**CITY OF PLATTSBURGH - DRI  
DOWNTOWN GRANT PROGRAM - PROPOSED FARMERS MARKET RE-BID**

**SECTION 00 9111  
ADDENDUM NUMBER 1**

**1.01 DATE: September 18, 2020**

**SK01**

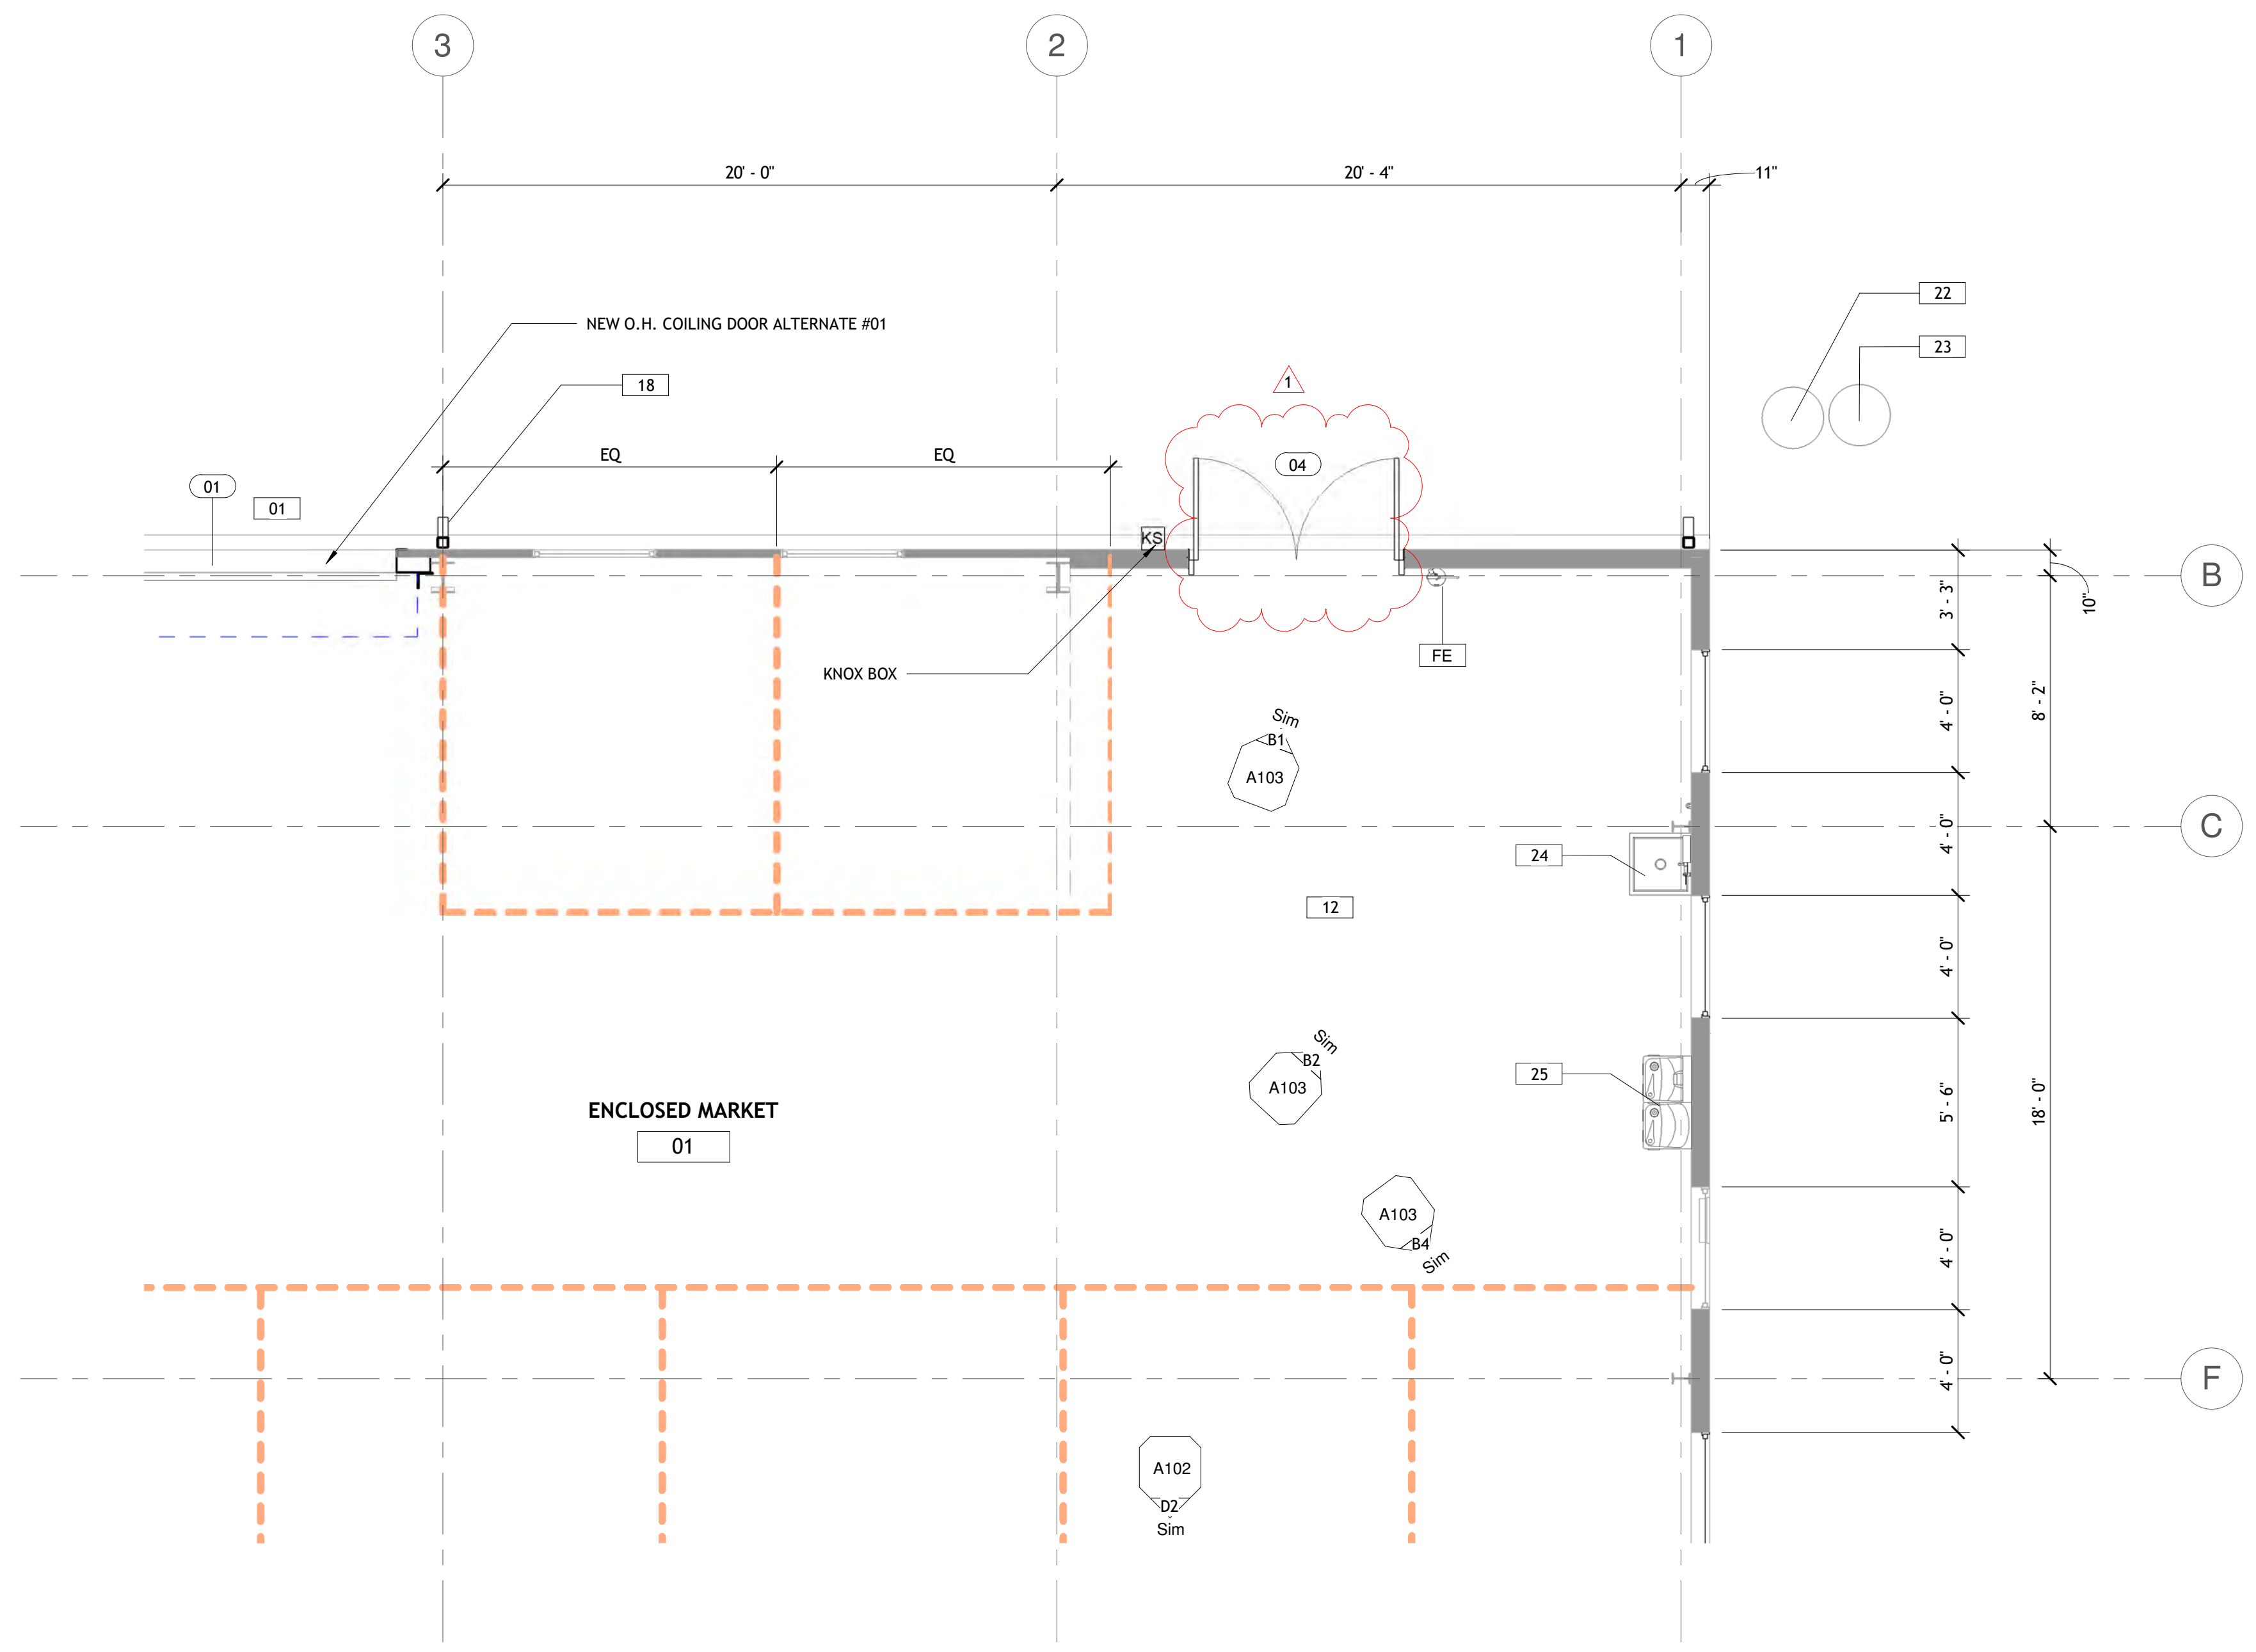
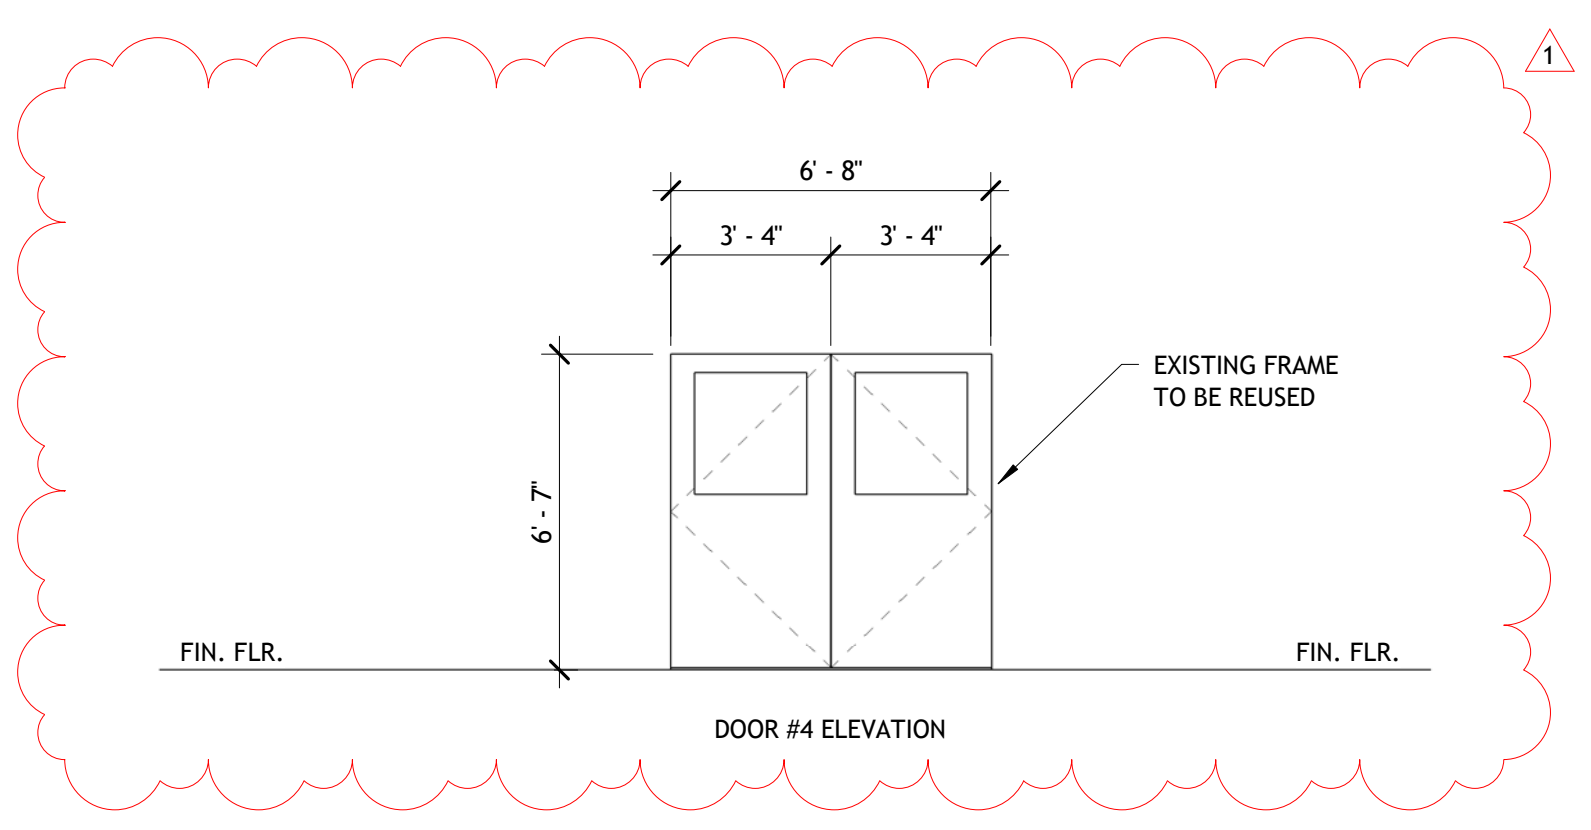
- B. **REVISE** – Drawing A103, Existing Conditions. **CHANGE** Tag #11, existing light fixtures, conduits, wiring, switches, etc. to remain. **CHANGE** Door 04 tag from #15 and **ADD** Tag #17 to replace Door 04 in accordance with the attached SK01 Door 04 Modification Sketch.

- C. **REVISE** – Drawing A601, Room, Door, and Window Schedules. **CHANGE** Door 04 schedule information to the information provided on the attached SK01.

G.C. TO VERIFY INSTALLATION OF DOOR 04 INTO EXISTING HOLLOW METAL FRAME. FRAME TO BE MODIFIED TO ACCEPT LOCKSET AND VERTICAL LOCKING. ASSURE WATER TIGHT ASSEMBLY
